**ADDRESS: 124 S 16TH ST**

Proposal: Legalize signage

Review Requested: Final Approval

**OVERVIEW:** This application proposes legalizing signage installed without a permit at 124 S. 16<sup>th</sup> Street. At the request of the Historical Commission's staff, the Department of Licenses and Inspections issued a violation for the signage installed without a building permit, prompting this request for legalization. The new signage includes a small projecting sign by the doorway and a large acrylic channel letter wall sign at the storefront transom. The storefront was installed in 1921, when the building transitioned from residential to mixed use. The Historical Commission previously approved an awning open at the sides and bottom as signage over the transom at this storefront.

Figure 3. 124 S. 16<sup>th</sup> Street storefront, July 2025.

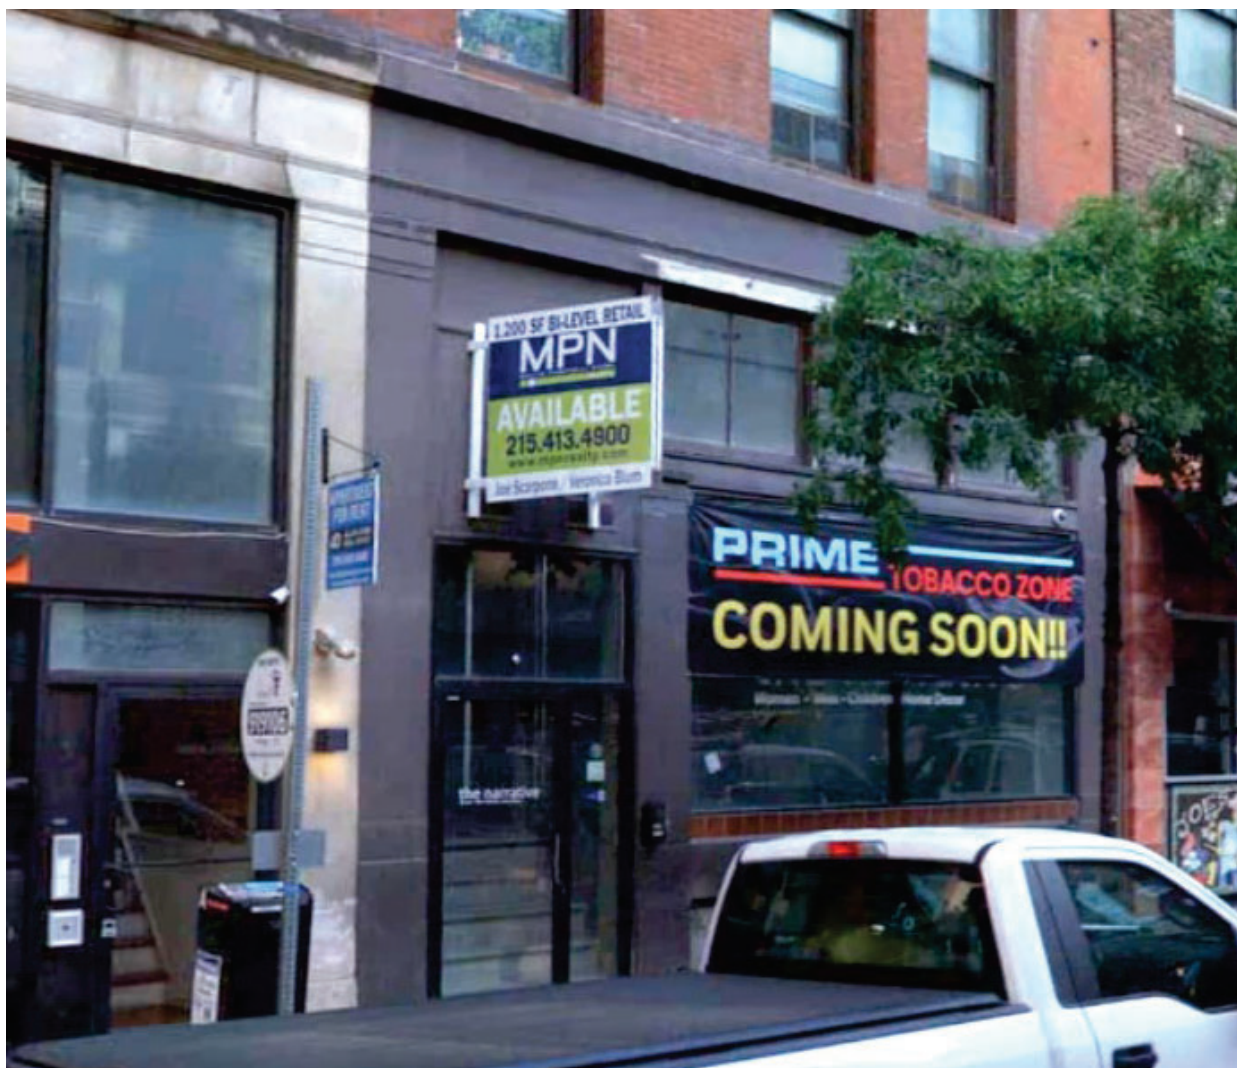
- *Standard 9: New additions, exterior alterations, or related new construction will not destroy historic materials, features, and spatial relationships that characterize the property. The new work will be differentiated from the old and will be compatible with the historic materials, features, size, scale and proportion, and massing to protect the integrity of the property and its environment.*
- *Storefronts Guideline | Not Recommended: Replacing or covering a glass transom with solid material or inappropriate signage, or installing an incompatible awning over it.*
  - The large wall sign is incompatible with the historic materials, features, size, scale and proportions of the historic building, and covers over the glass transom. This application fails to satisfy Standard 9 and the Storefronts Guideline.

**STAFF RECOMMENDATION:** Denial, pursuant to Standard 9 and the Storefronts Guideline.
